Using COM to calibrate the interference tolerance test for 100GBASE-CR4

Mike Dudek QLogic

January 22 2014

- This presentation is in support of comment i-136.
- Draft 3.0 of 802.3bj uses an interference tolerance test to test the host Rx for 100GBASE-CR4. The interference tolerance test uses the test system below.

Figure 92–8—Interference tolerance test setup

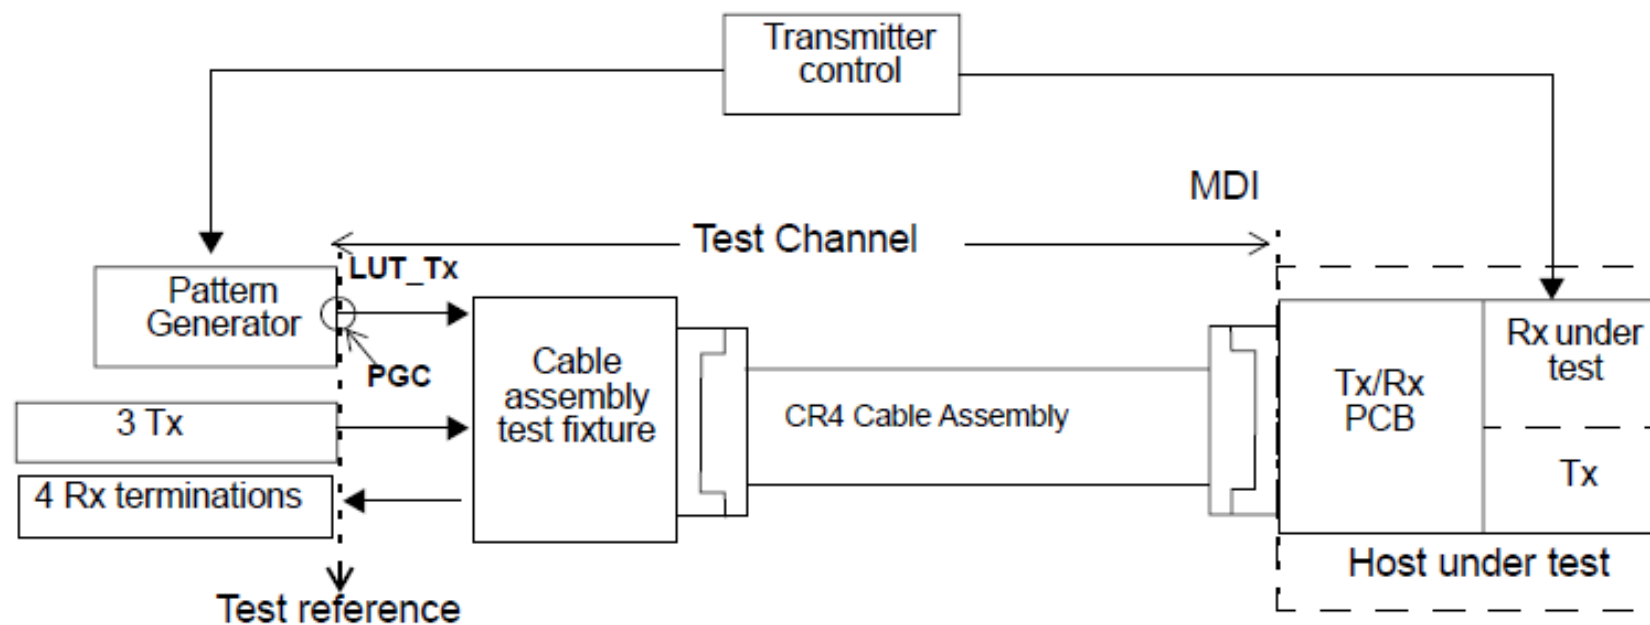
- Insert a new paragraph on page 210 at line 39. “The COM shall be calculated using the method and parameters of section 92.10.7 with the following exceptions.
 - The Channel signal path is $\text{cascade}(\text{cascade}(S^{(\text{CTSP})}, S^{(\text{HOSP})}))$ where $S^{(\text{CTSP})}$ is the measured channel between the test references for the LUT in figure 92.9
 - The Channel far end crosstalk path is $\text{cascade}(\text{cascade}(S^{(\text{CTFXTk})}, S^{(\text{HOSP})}))$ where $S^{(\text{CTFXTk})}$ is the measured FEXT channel between the test references in figure 92.9 between the 3Tx and the LUT_Rx
 - The value of the far-end aggressor amplitude (A_{fe}) is adjusted until the required COM is achieved. The far end aggressors peak to peak amplitude (3Tx in figure 92.8) is set to twice the resulting value for the test.”

Figure 92–9—Test channel calibration

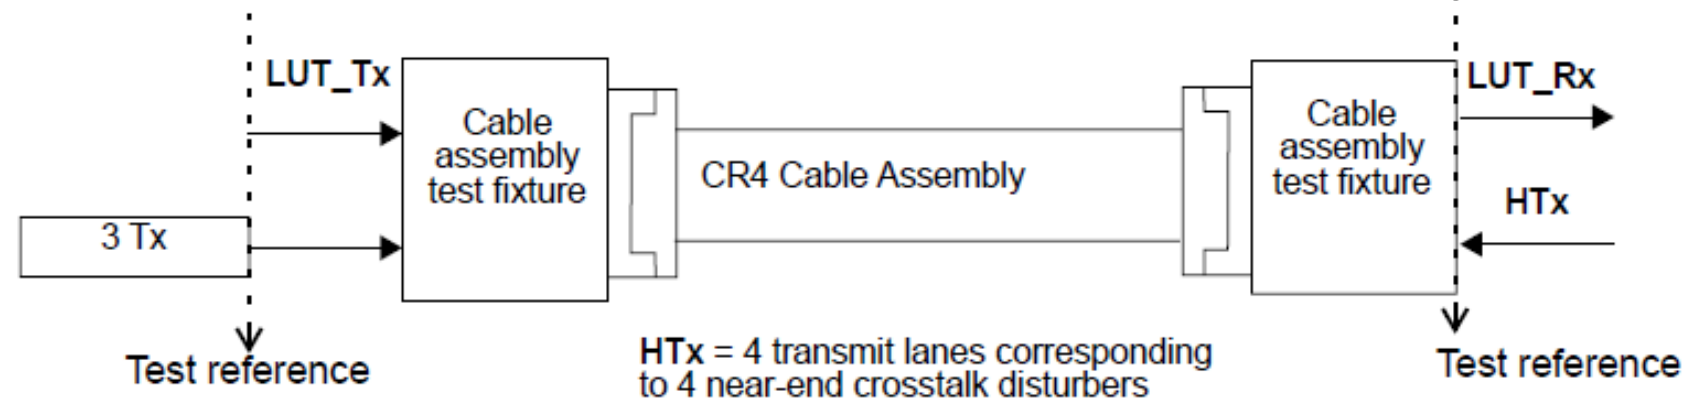
- **The description of the channel states that the lane under test shall meet a specified fitted insertion loss curve but then states “It is recommended that the deviation between the insertion loss and the fitted insertion loss be as small as practical and that the fitting parameters be as close as practical to the values given in Table 92-8”. Unfortunately it is unlikely that the fitted insertion loss will be exactly as specified with zero Insertion Loss deviation. Any deviations from this will result in variability in the test.**

- **Use COM to calibrate the interference tolerance test similar to how it is done in Clause 93.**
- **The existing test setup can be used but instead of adjusting FEXT to a given fixed value the FEXT would be adjusted to create the required COM.**
- **The appropriate COM uses a channel that is the test channel plus the extra loss that is the TP4 to TP5 loss representing the allocated additional loss in the DUT Host Rx.**

- In table 92-8 replace the calibrated far-end crosstalk row with “COM, including the effect of adjusted FEXT” with value to match the allowed cable COM value (3dB in draft 3.0)
- On page 210 line 5 replace “and far-end crosstalk with “and S parameters”
- On page 210 line 35 Replace “The amplitudes of each of the disturbers should not deviate more than 3 dB from the mean of the disturber amplitudes. The amplitudes of the disturbers should be such that the calibrated far-end crosstalk in Table 92–8 is met in the calibration setup at the LUT point with no signal applied at the PGC, and HTx and PGC terminated in 100 Ohms differentially.” **With** “The amplitudes of each of the disturbers should be set to the value that results in the COM value given in table 92-8 when calculated by the method given below
